## PLANNING AND ZONING CASE CHECKLIST City of Rockwall Planning and Zoning Department

### RIVERROCK TRAILS, PHASE 1A

08/05/2020: Revision 1 Comments - P2020-029; Preliminary Plat for RiverRock Trails, Phase 1A Addition - ETJ Please address the following comments (M= Mandatory Comments; I = Informational Comments)

ERROCK TRAILS, PHASE 1A - PRELIMINARY PLAT

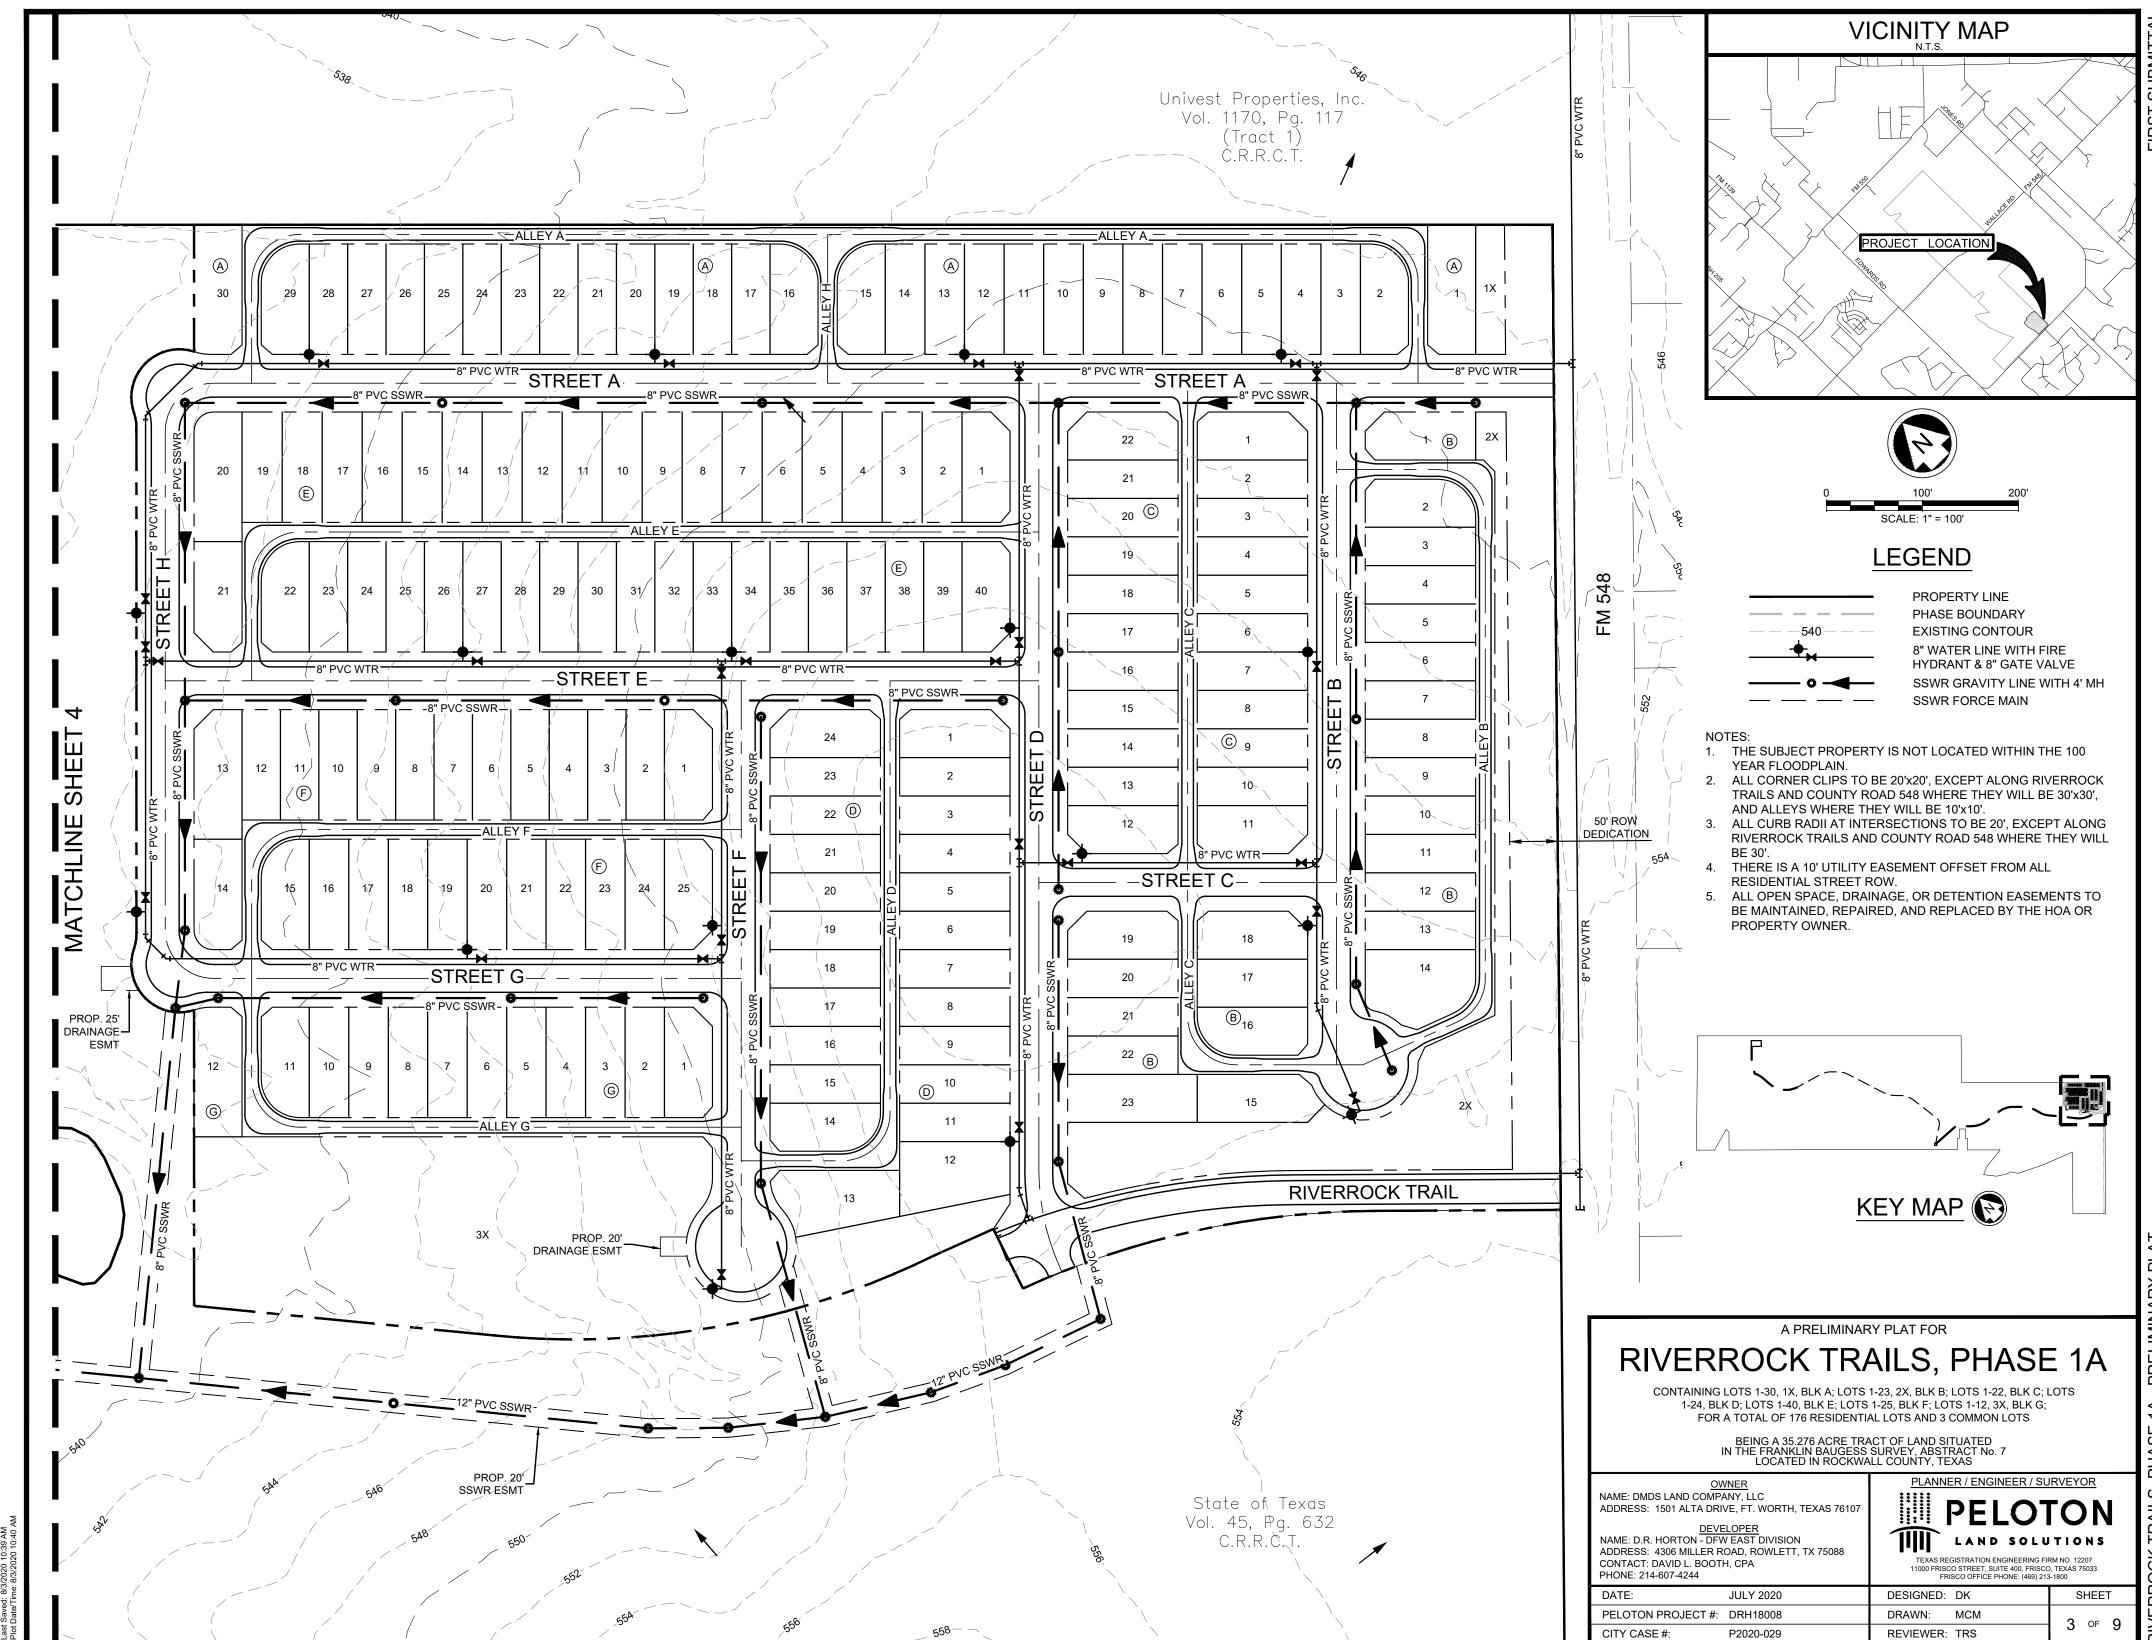
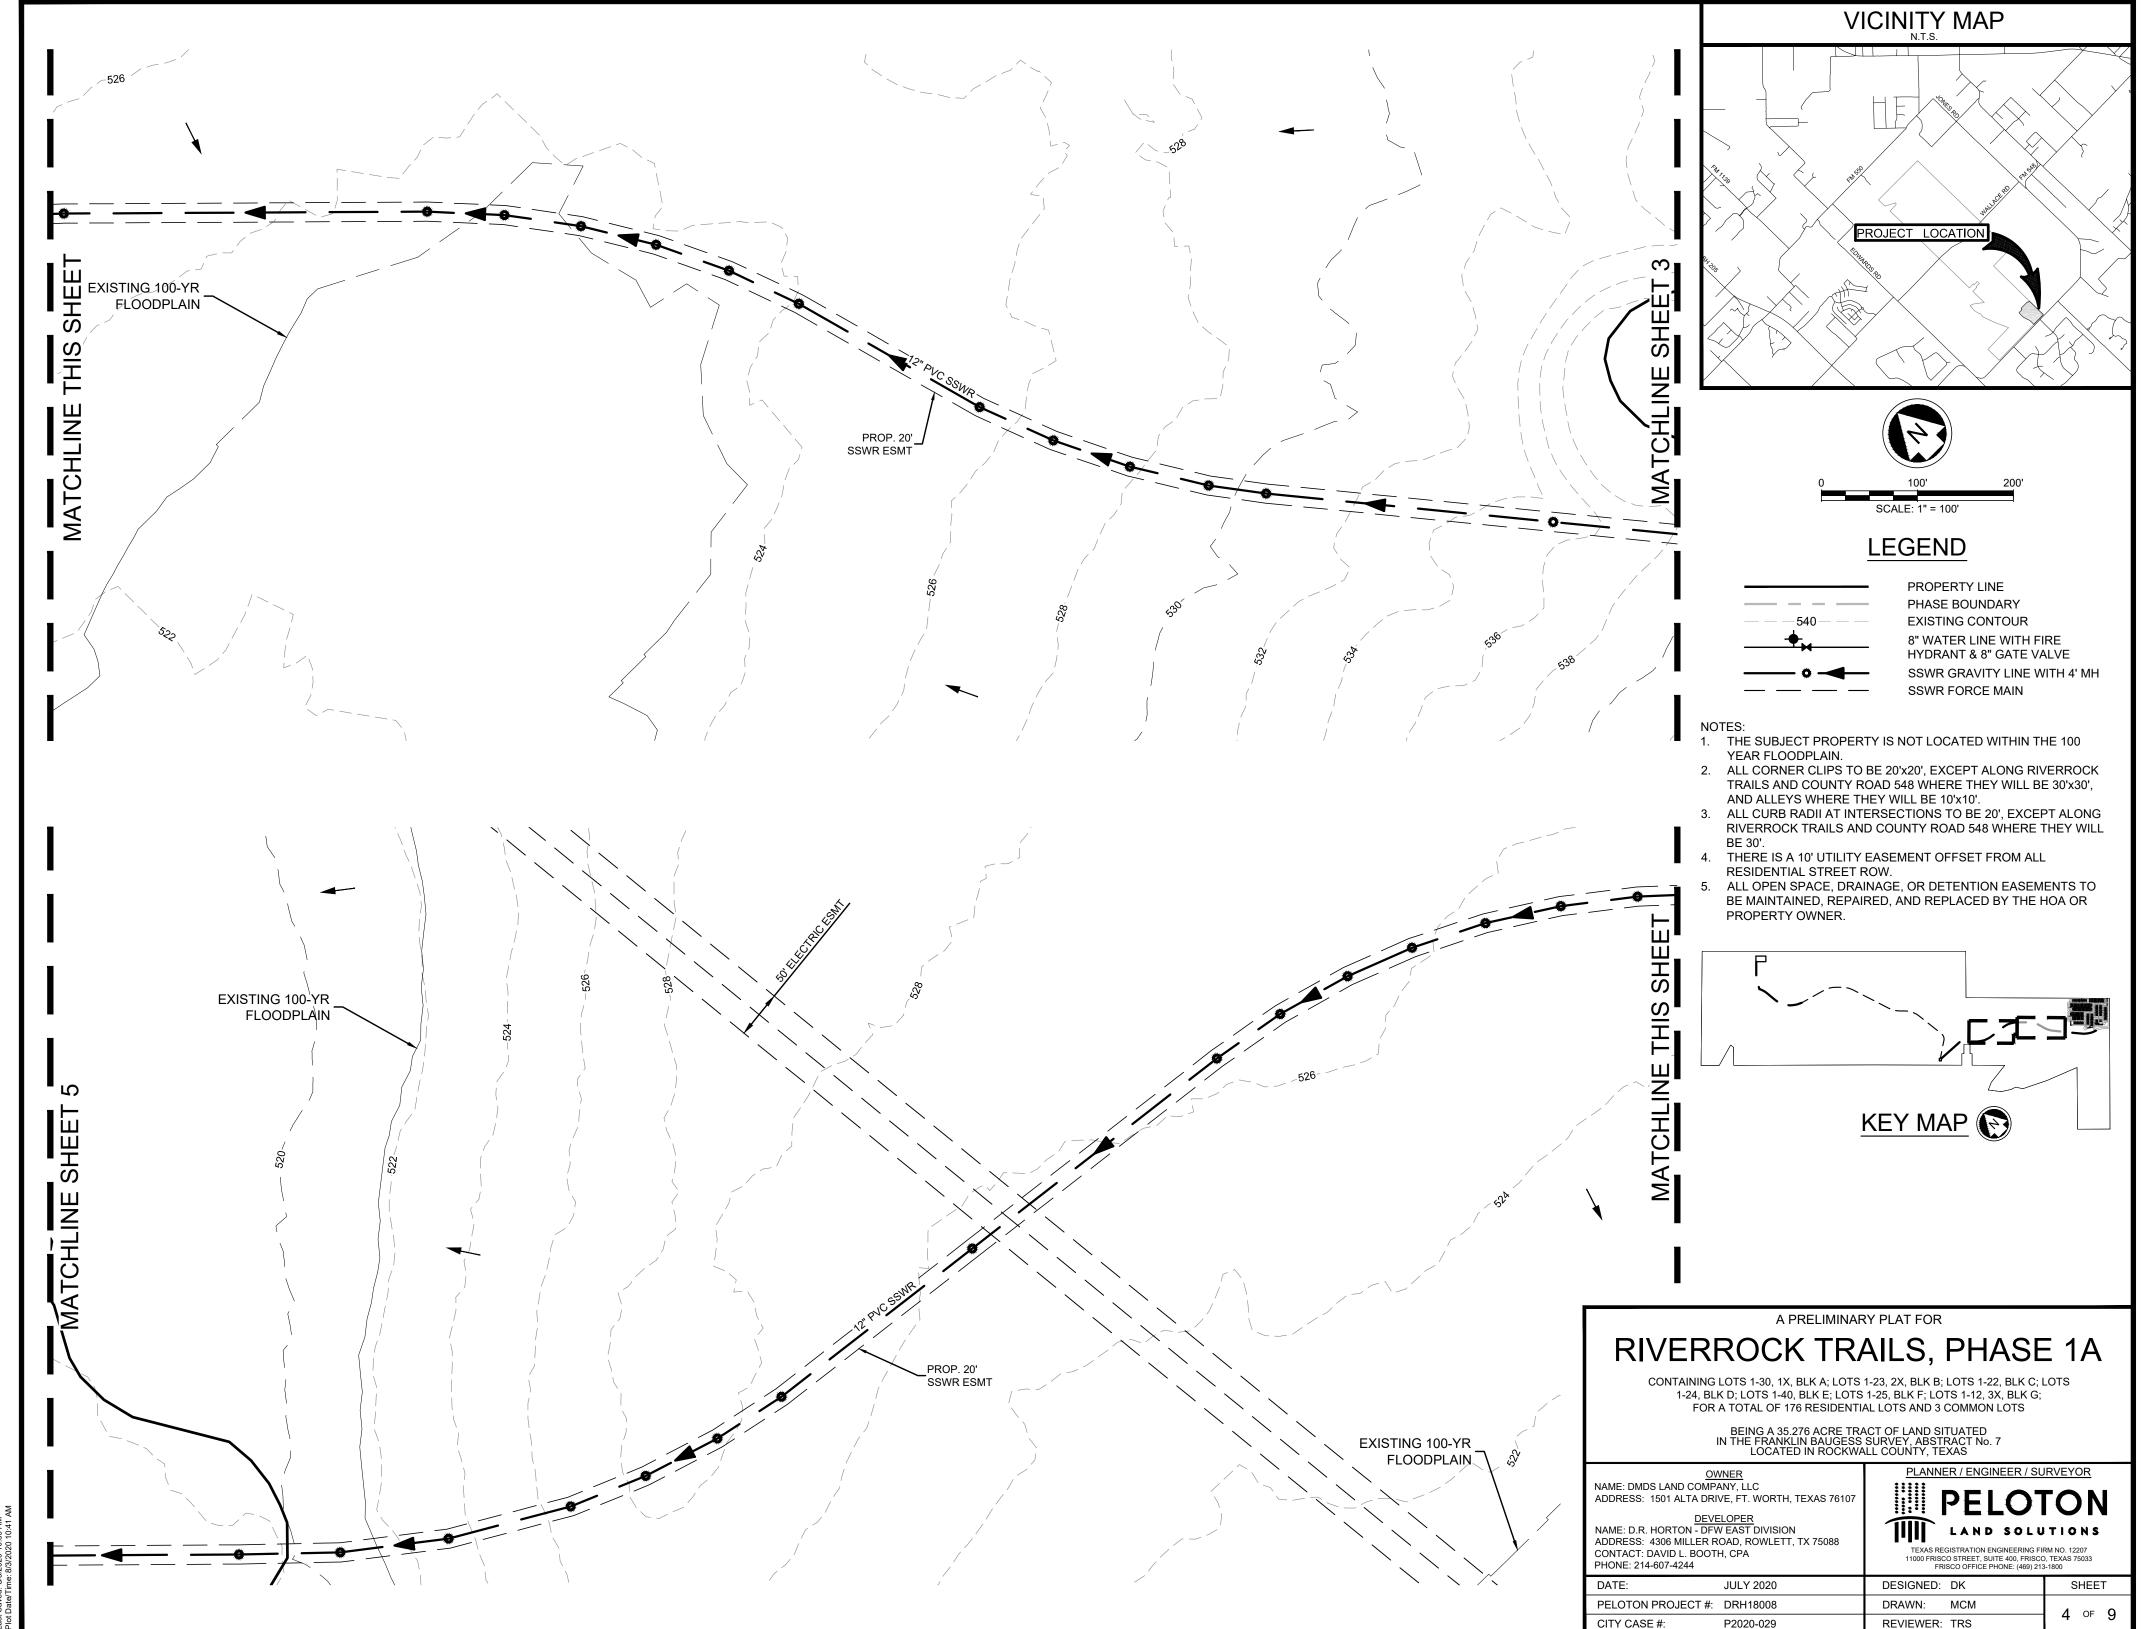
- M.3 Identify the dimensions, names and description of all open spaces, both existing and proposed. Provide labels for the three (3) common areas to indicate "Open Space." (Section 38-8(b)(6)e, Plat Contents, Municipal Code of Ordinances)

- M.4 Please refer to the Checklist for Plat Submittals as found in the Interim Interlocal Cooperative Agreement for Subdivision Regulation (ILA) document and make the following corrections and/or provide a statement for each of the following items. Refer to the language in Exhibit 'A' of the ILA: (Exhibit 'A', ILA)

- a) Provide a detailed statement of how the proposed subdivision will be served by water, wastewater, roadway and drainage facilities that have adequate capacity to serve the development. (Exhibit 'C', ILA)

- b) Provide the appropriate plat wording provided in the application packet that details the designation of the entity responsible for the operation and maintenance of any commonly held property and a waiver releasing the city of such responsibility, a waiver releasing the City for damages in establishment or alteration of grade. (Section (5) (a)(b), Certification and Dedication Language, Exhibit 'A', ILA)
